### 20160224 RE-BID SUMNER COUNTY INFRASTRUCTURE UPGRADE

# **Sumner County BOE Voice and Data Technical Specification**

### Questions and Answers

Portland East Middle:

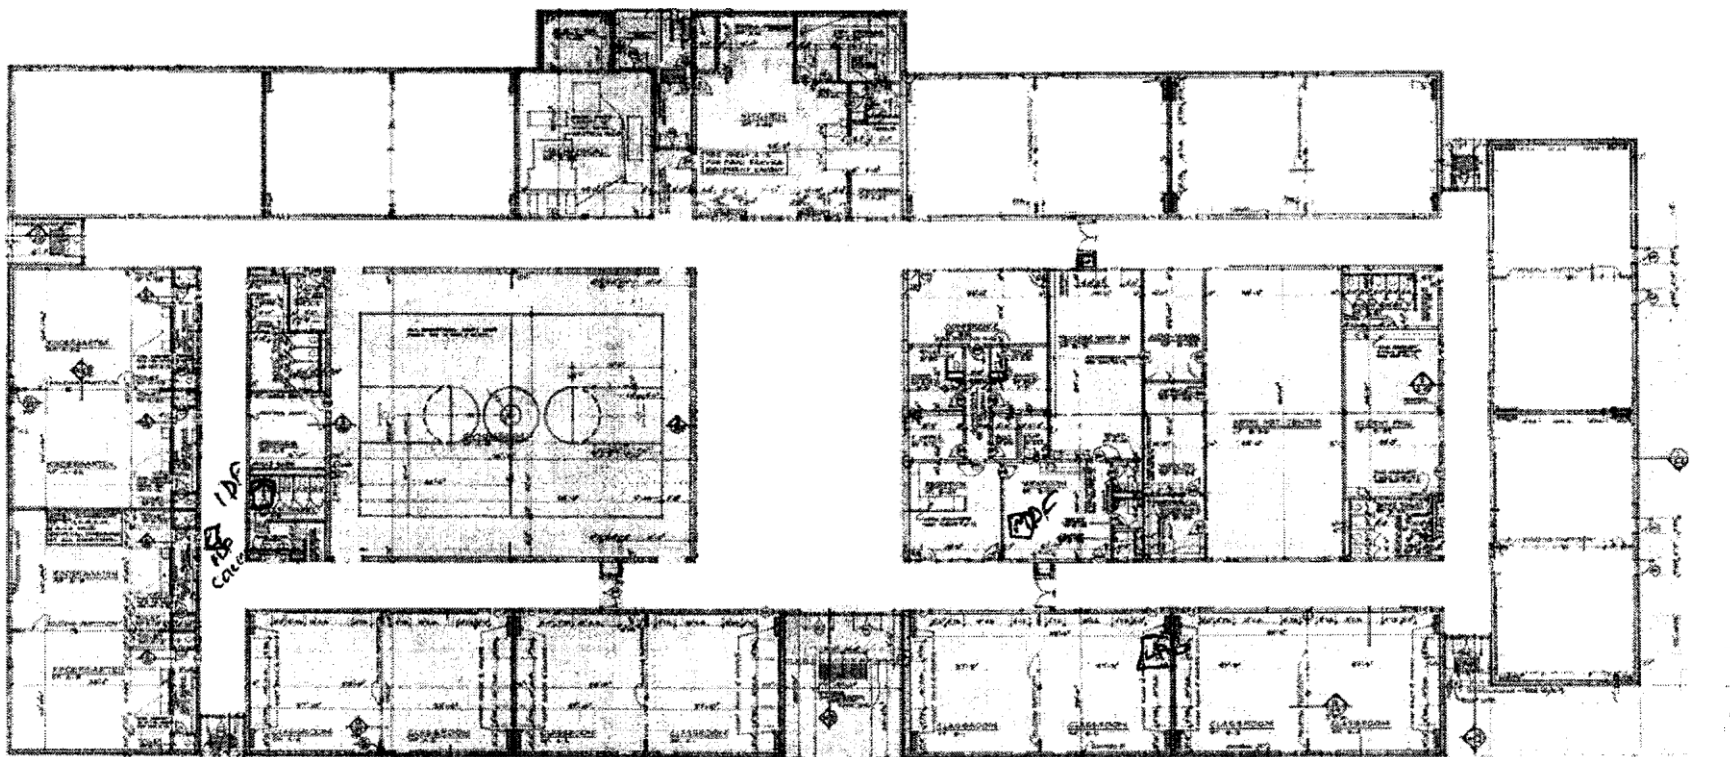
Will need 1 fiber run.
